## **STRATFORD PLACE SUBDIVISION**

APPLICATION NUMBER 7 DATE May 3, 2007

# DETAIL SITE PLAN

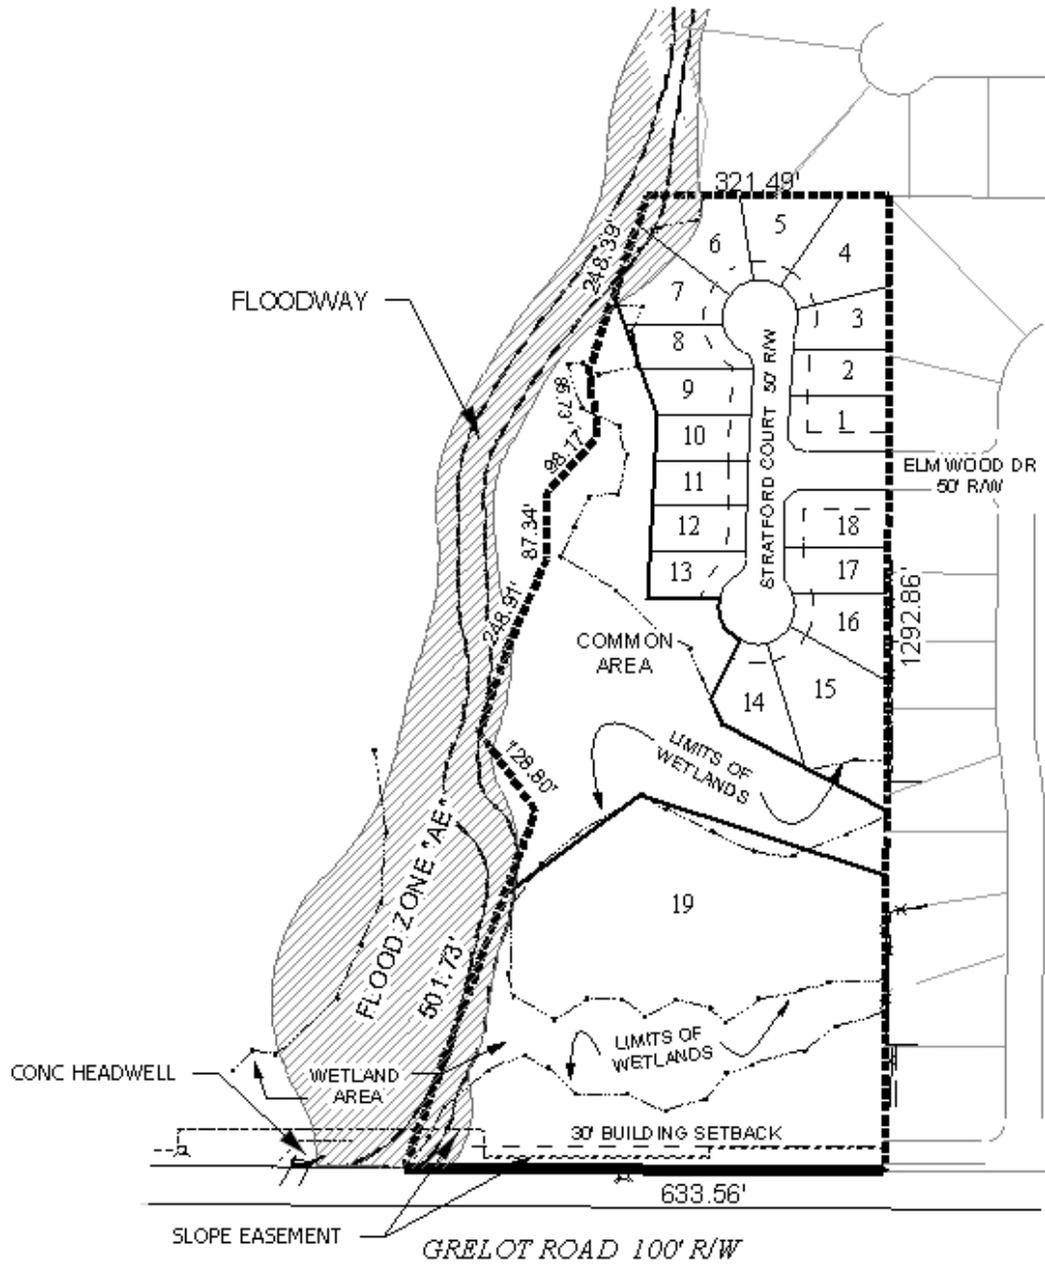
Engineering Comments: Add note to plat stating that no work in the wetlands is allowed without a permit from the Corps of Engineers. Show minimum finished floor elevation on each lot in the AE flood plain. Show location of storm water detention on plat. No detention can be performed in the AE flood plain. No fill is allowed in the AE flood plain without compensation. Any impact on the floodway must comply with FEMA regulations and City of Mobile Engineering Department standards. Must comply with all storm water and flood control ordinances. Any work performed in the right of way will require a right of way permit.

Traffic Engineering Comments: Driveway number, sizes, location and design to be approved by Traffic Engineering and conform to AASHTO standards.

The new road from Chimney Top Drive West to the site is to be dedicated and constructed to meet City Engineering Standards. Additionally, since Lots 1 and 18 are corner lots, a note should be placed on the Final Plat stating that Lots 1 and 18 are limited to one curb-cut each with the size, design and located to be determined by Traffic Engineering.

It appears that each lot meets the minimum size requirements for developments with access to public water and sewer. Due to the size of the proposed development, it is requested that the applicant revise the preliminary plat to provide the size of each lot in square feet on the plat, either as a table or as a label for each individual lot.

The site is bounded to the West by wetlands illustrated as a floodway on the preliminary plat. The presence of wetlands indicate that the area may be environmentally sensitive; therefore, the

approval of all applicable federal, state and local agencies would be required prior to the issuance of any permits or land disturbance activities.

The plat meets the minimum requirements of the Subdivision Regulations and is recommended for Tentative Approval, subject to the following conditions:

- 1) the placement of a note on the Final Plat limiting Lot 19 to one curb cut to Grelot Road, with the size, location and design to be approved by Traffic Engineering;

- 2) dedication and construction of the new road from Chimney Top Drive West to the development to meet City Engineering Standards;
- 3) placement of a note on the Final Plat stating that Lot 1 and 18, corner lots be limited to one curb cut each, with the size, location and design to be approved by County Engineering;

- 4) labeling of all lots with size in square feet, or provision of a table with the lot size information on the plat;
- 5) compliance with Engineering Comments (Add note to plat stating that no work in the wetlands is allowed without a permit from the Corps of Engineers. Show minimum finished floor elevation on each lot in the AE flood plain. Show location of storm water detention on plat. No detention can be performed in the AE flood plain. No fill is allowed in the AE flood plain without compensation. Any impact on the floodway must comply with FEMA regulations and City of Mobile Engineering Department standards. Must comply with all storm water and flood control ordinances. Any work performed in the right of way will require a right of way permit); and

- 6) the approval of all applicable federal, state and local agencies prior to the issuance of any permits.
